Subject: UniStar Nuclear Energy, NRC Docket No. 52-016
Response to Request for Additional Information for the
Calvert Cliffs Nuclear Power Plant, Unit 3,
RAI No. 177, Fire Protection Program

**Response to NRC Request for Additional Information
RAI No. 177, Question 09.05.01-14, Fire Protection Program,
Calvert Cliffs Nuclear Power Plant, Unit 3**

Question 09.05.01-14

Figure 1 – Schematic Plan of TI Structure Shear Walls

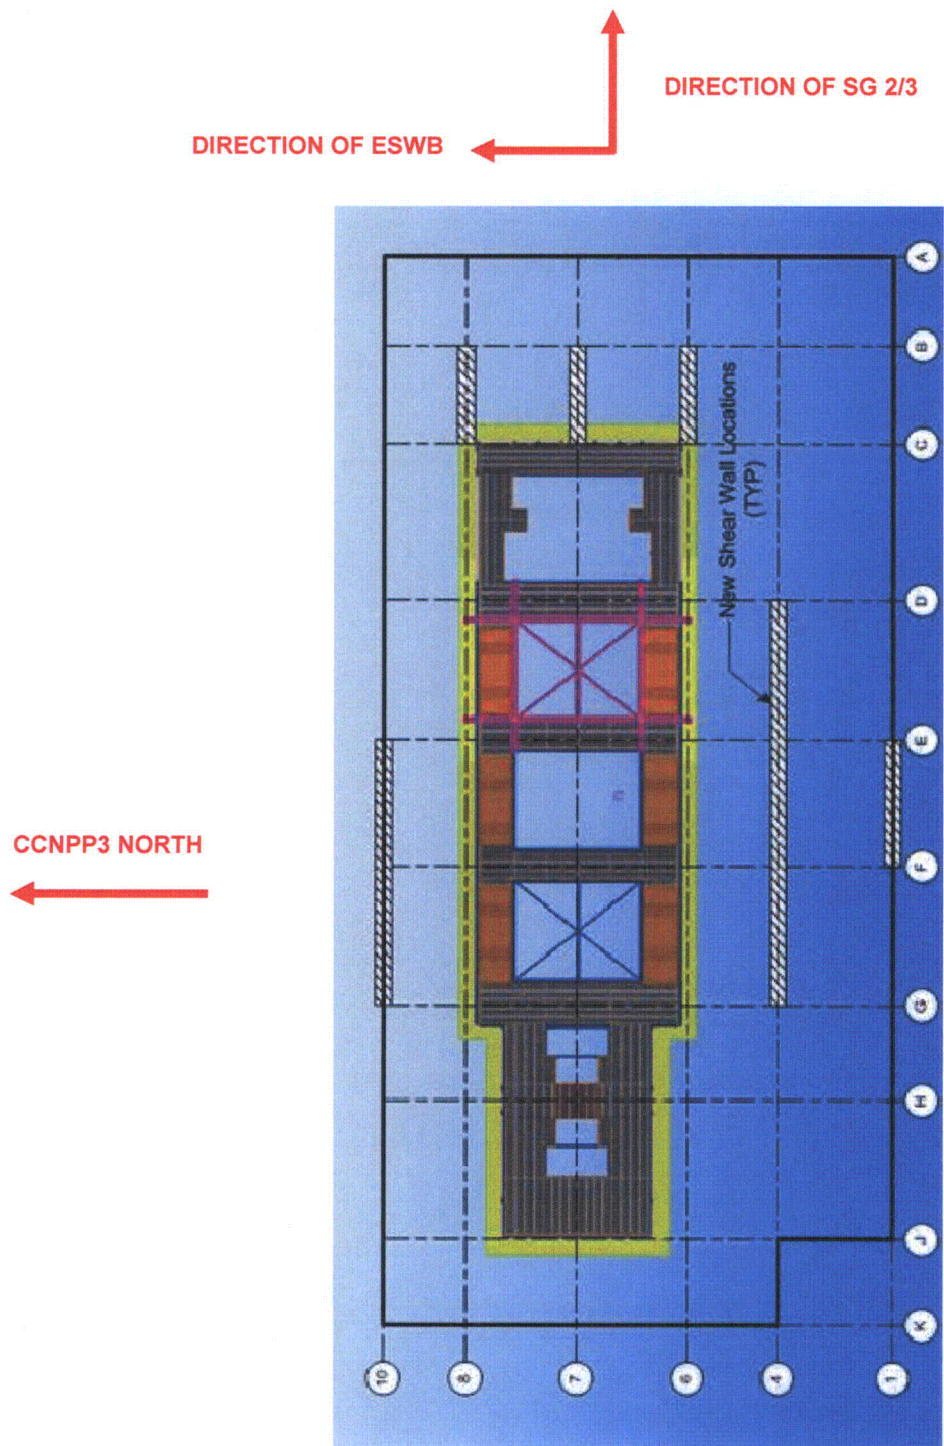
RG 1.189 Regulatory Position 7.2 states that "The turbine building should be separated from adjacent structures containing equipment important to safety by a fire barrier with a rating of at least 3 hours. The fire barriers should be designed to maintain structural integrity even in the event of a complete collapse of the turbine structure. Openings and penetrations in the fire barrier should be minimized and should not be located where the turbine oil system or generator hydrogen cooling system creates a direct fire exposure hazard to the barrier." It is not apparent from Section 9.5.1 and Figures 9B-1 through 7 if the turbine building wall facing the nuclear island is a 3 hour rated barrier and whether the barrier is designed to maintain structural integrity even in the event of a complete collapse of the turbine structure. It is also not apparent from Section 9.5.1 and Figures 9B-1 through 7 if the turbine building wall facing the Switchgear Building is designed to maintain structural integrity even in the event of a complete collapse of the turbine structure. The applicant needs to follow the guidance in RG 1.189 or demonstrate that the existing barriers are acceptable and revise Section 9.5.1 and Figures 9B-1 through 7, as applicable. Additionally in the above figures, explain the meaning of Alternate in "Alternate Turbine Building".

The design of the TI structure includes nominally three-foot thick reinforced concrete shear walls aligned along the east-west direction at and below the Turbine Generator (TG) operating deck of the Turbine Building. The reinforced concrete shear walls and the reinforced concrete floor diaphragms are designed to prevent collapse of the Turbine Building at and below the operating deck in the east-west direction perpendicular to SG 2/3 (Figure 1). Thus, the design eliminates the potential for lateral impact of the substantial mass associated with self weight and equipment weight of the Turbine Building at and below the operating deck level onto the SG 2/3 wall. Figure 1 illustrates the conceptual locations of the reinforced concrete walls in the plan.
